*IEEE 802.3cg*  
*PLCA Burst mode fixes*  
*November 28<sup>th</sup>, 2018*

# Proposed solution

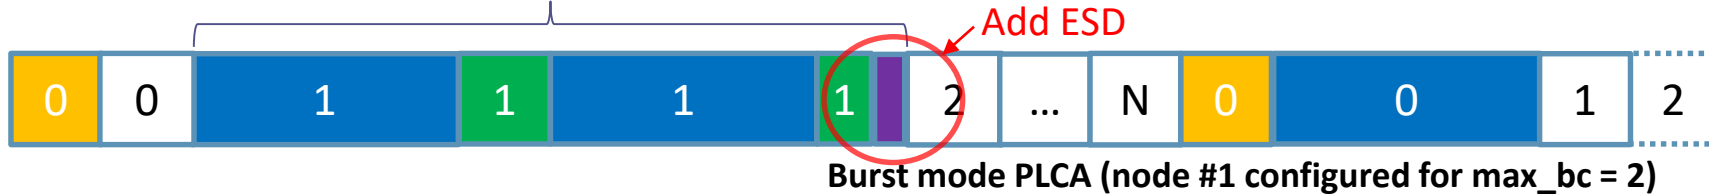
node #1 sends a burst of 2 packets, and needs to append an empty COMMIT

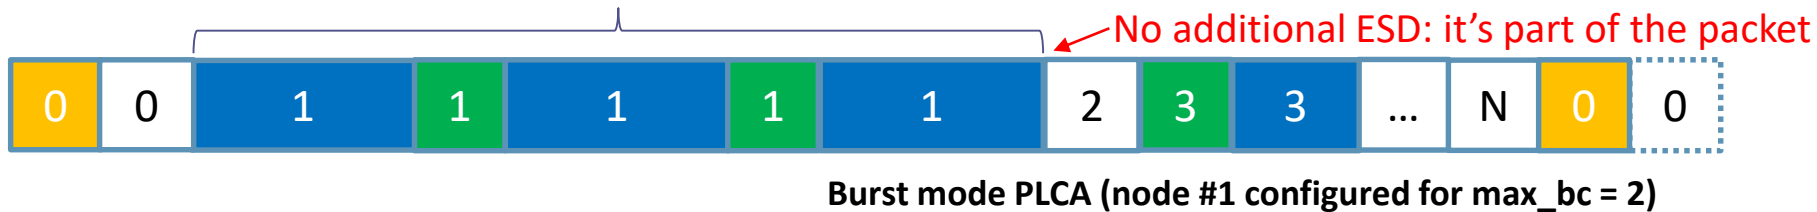
node #1 sends a burst of 3 packets (max) and does not append a COMMIT

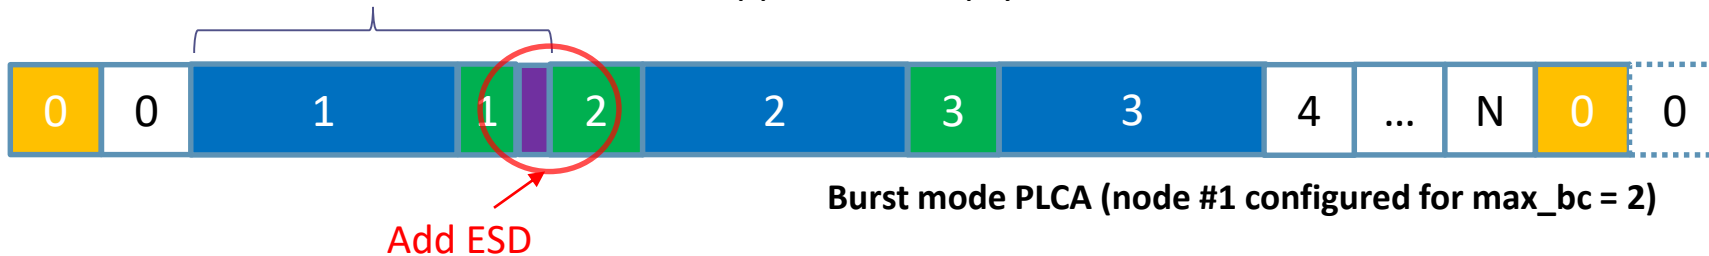
node #1 does not burst but still needs to append an empty COMMIT

Figure 147-4 – PCS Transmit state diagram (part a)

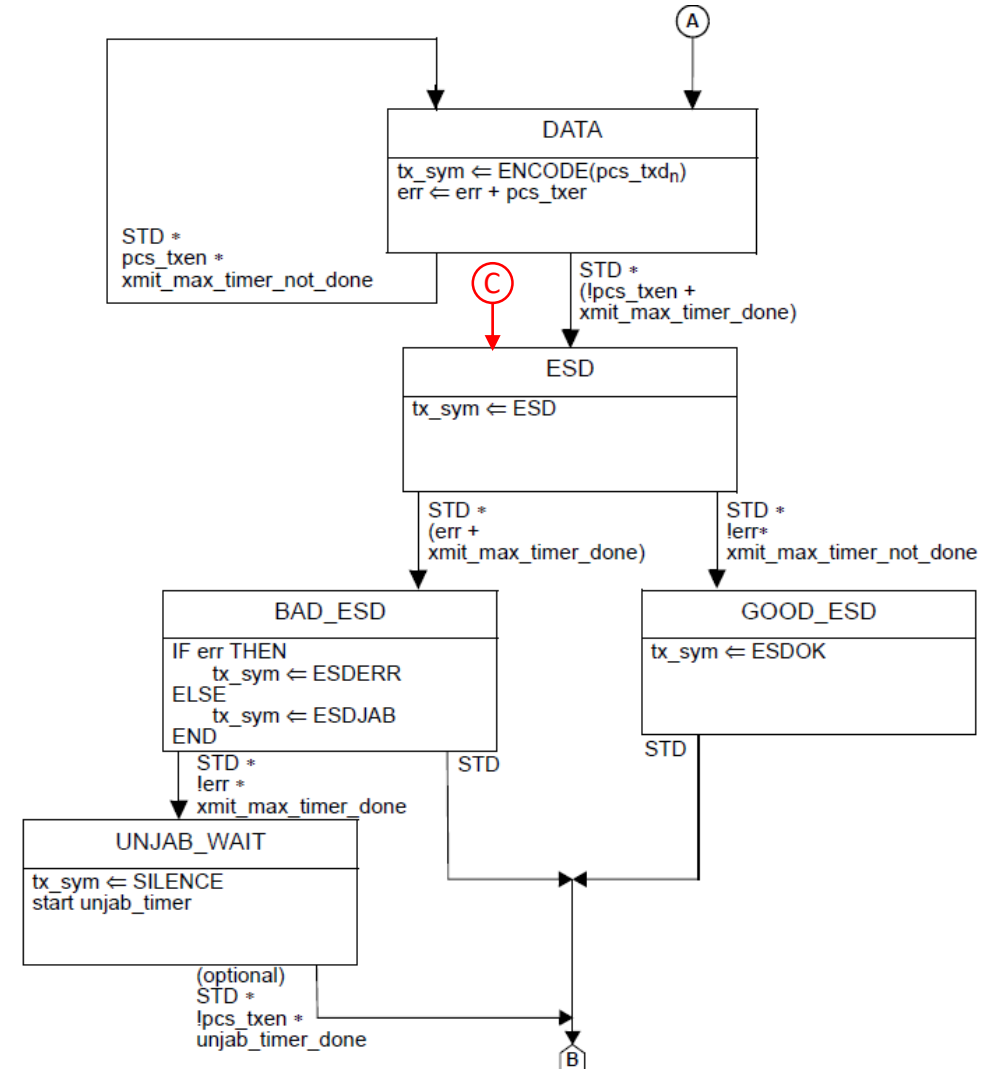
# PCS TX state diagram changes

- Use explicit ESD, ESDOK 5B symbol sequence to end a COMMIT request when the MAC has no more packets to send in a burst
  - This prevents the spurious “FALSE carrier” indication
- Increase minimum DME silence period to guarantee at least one full 5B symbol of silence afterwards
- State diagram fix to Clause 147
  - The number of changes may look significant but the actual *—functional—* modification is very limited
- State diagram fix to Clause 148

Figure 147-7—PCS Receive state diagram (part a)

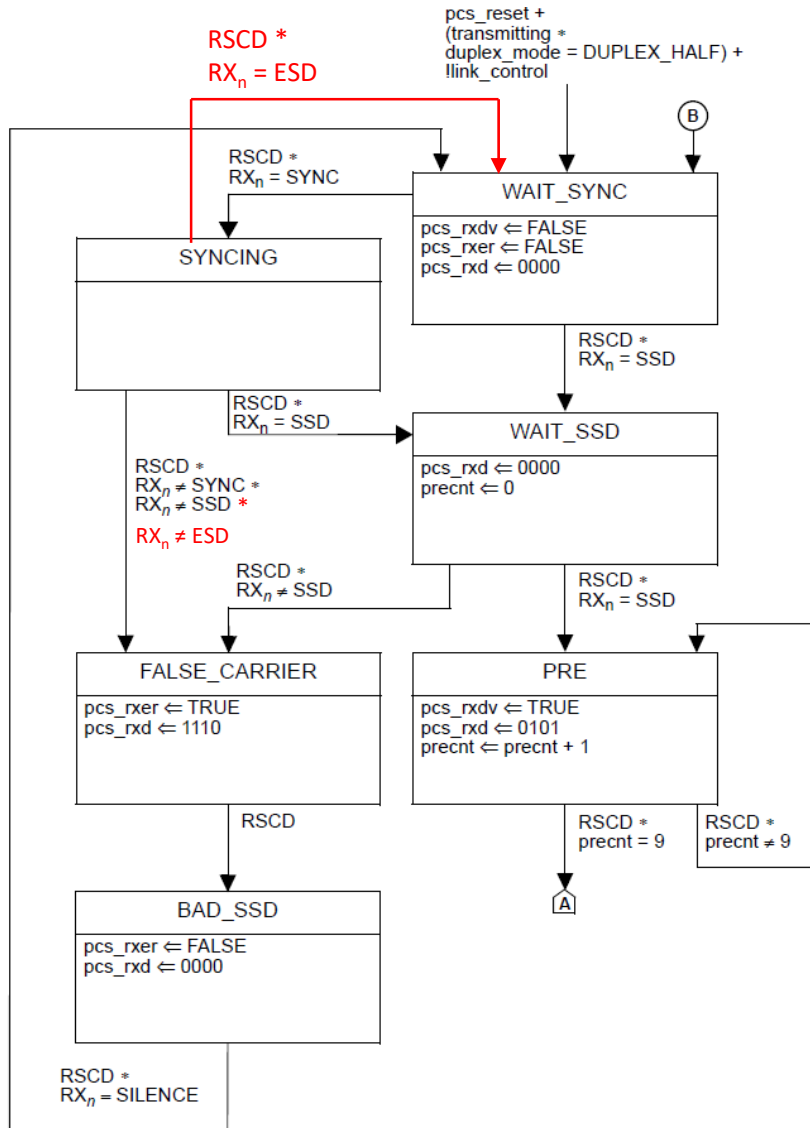
# PMA and PCS RX state diagram changes

Figure 147-11—DME Encoding Scheme

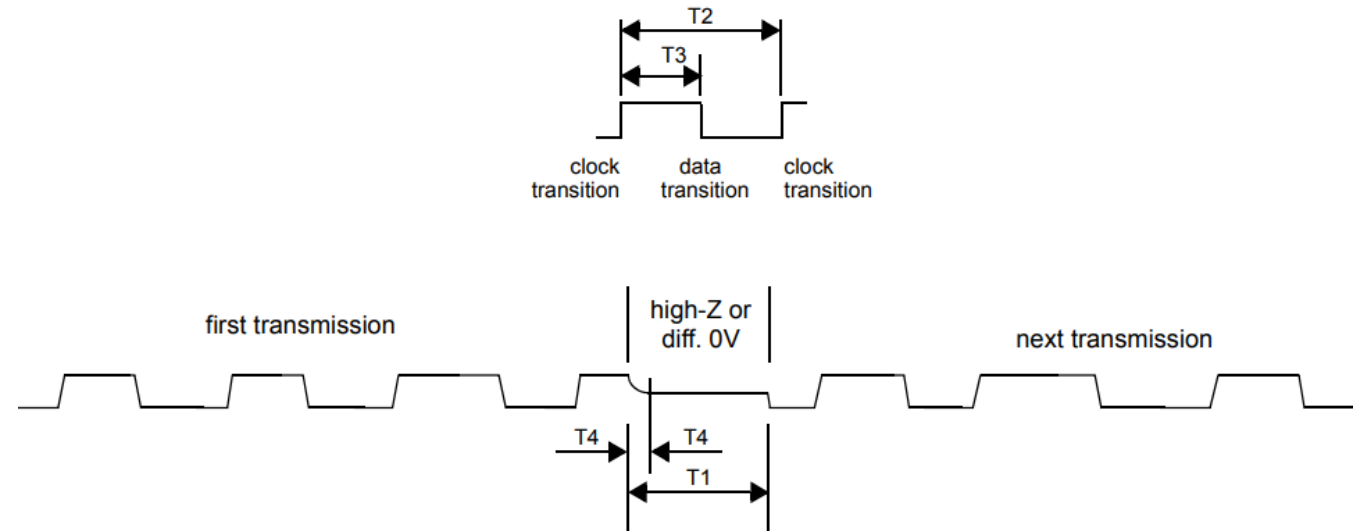
| Parameter name | Description                                    | Minimum value      | Nominal value | Maximum value | Unit of measure |
|----------------|--|--------------------|---------------|---------------|-----------------|
| T1             | Delay between transmissions                    | <del>200</del> 480 | —             | —             | ns              |

480 ns is one 5B symbol + 1 DME encoded bit

Figure 148-5—PLCA DATA state diagram

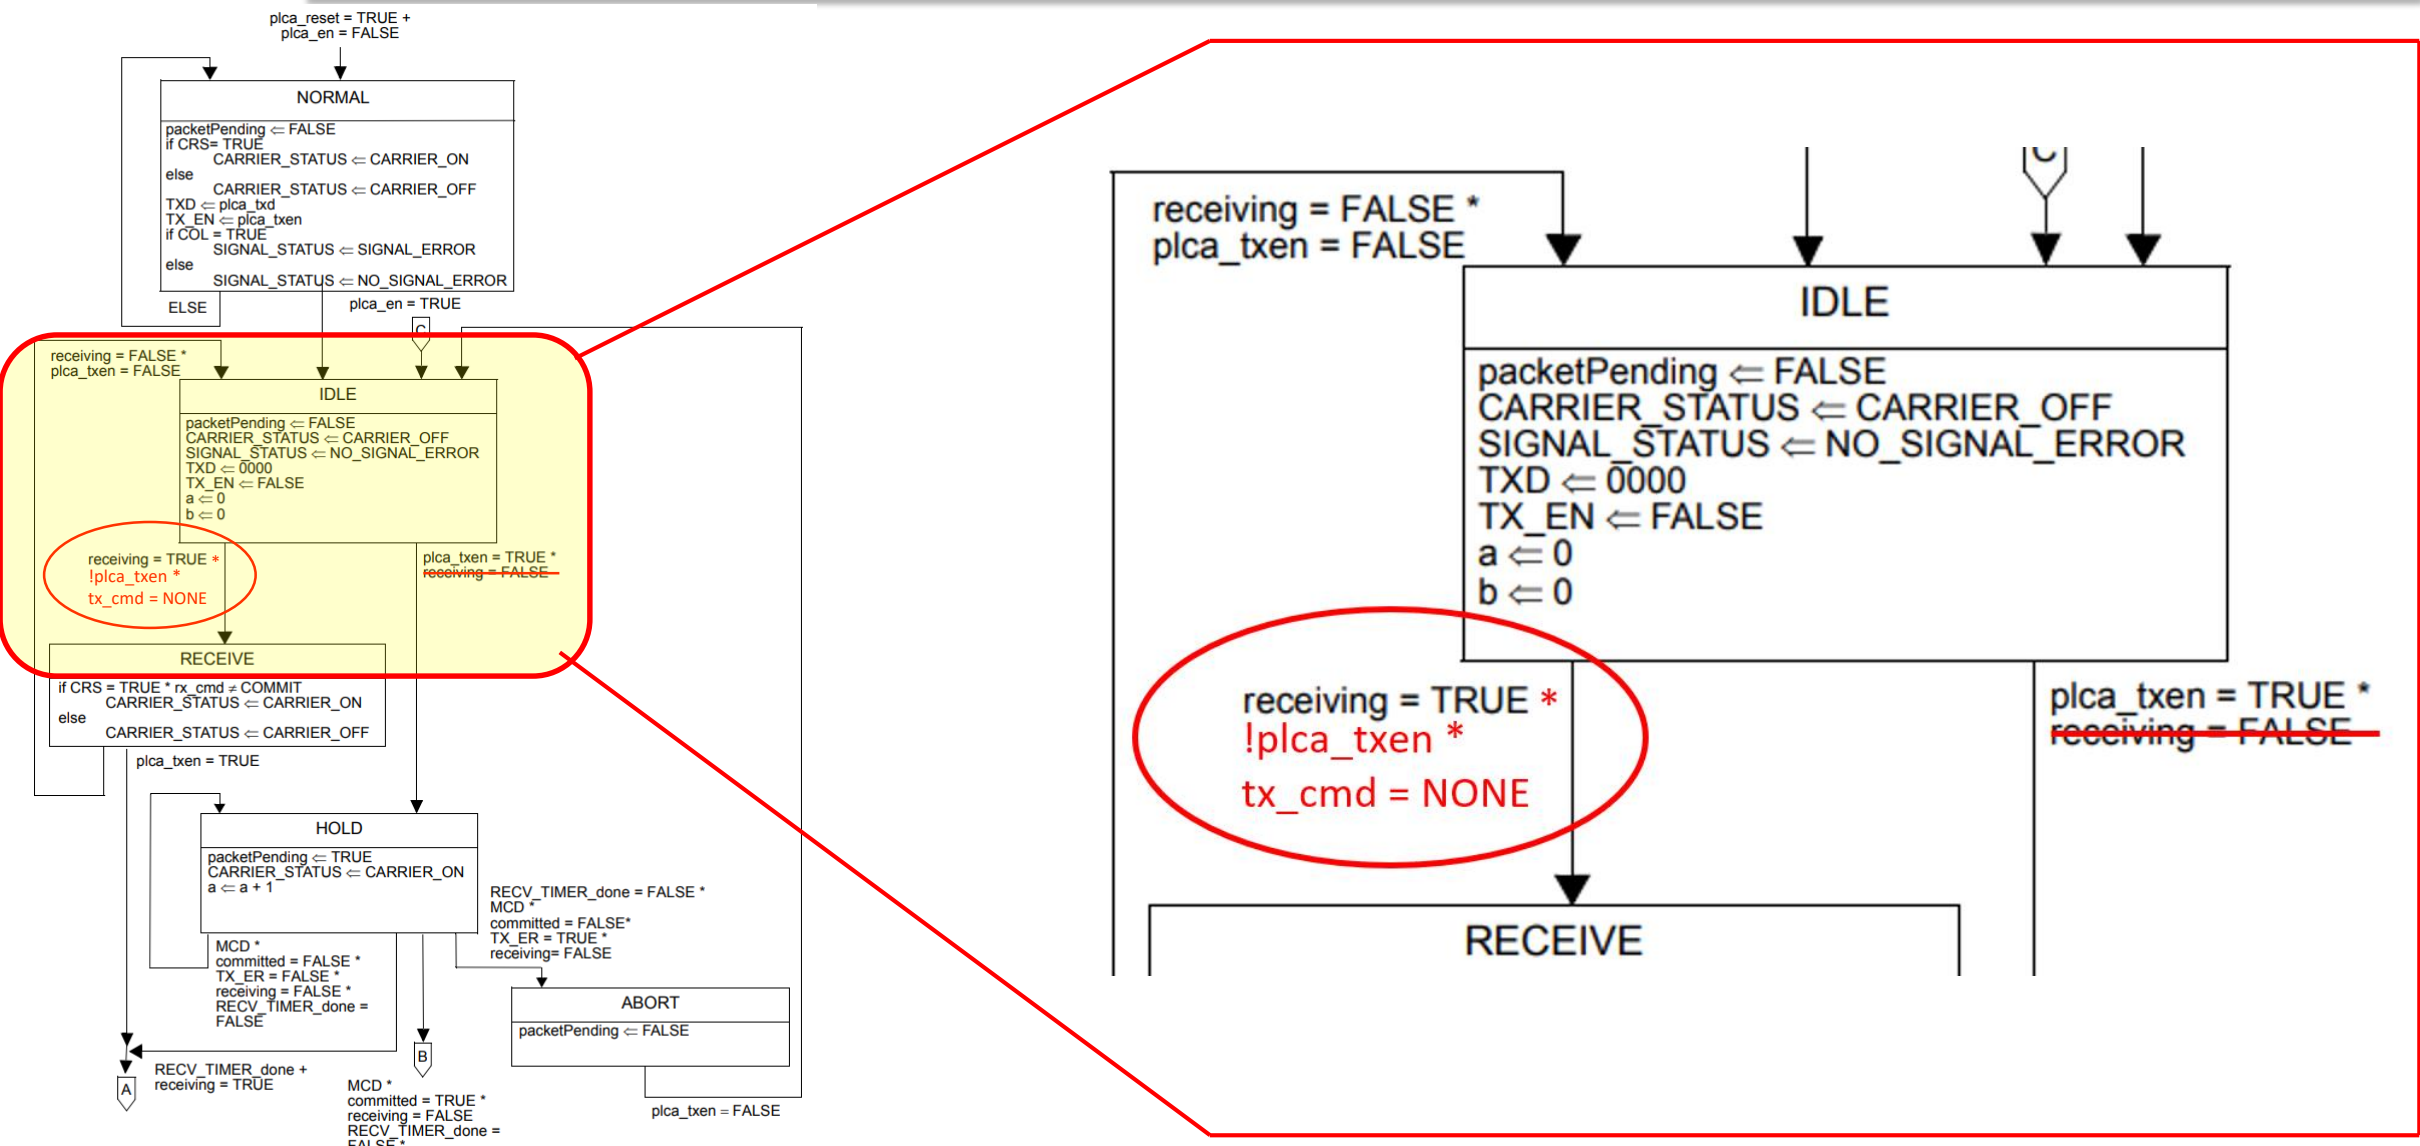
- PLCA burst mode has been added to Clause 148 in draft 2.2 as per [http://www.ieee802.org/3/cg/public/Nov2018/beruto\\_3cg\\_PLCA\\_burst\\_mode\\_rev\\_B%20.pdf](http://www.ieee802.org/3/cg/public/Nov2018/beruto_3cg_PLCA_burst_mode_rev_B%20.pdf).
- The addition of this new feature created a (minor) problem in Clause 147
  - A COMMIT (coded as 'J' in 4B/5B) is added at the end of a packet when burst mode is enabled
    - Such COMMIT can be followed by either a packet or **silence**.
    - **In the latter case the PCS RX signals a “False carrier” on the MII**
      - This is not supposed to happen since it's normal burst mode behavior
- Besides, there was one missing change for Clause 148
  - Depending on implementation (internal delays), PLCA DATA State Diagram could detect a false reception when filling the IPG with idle.

# PLCA DATA state diagram changes
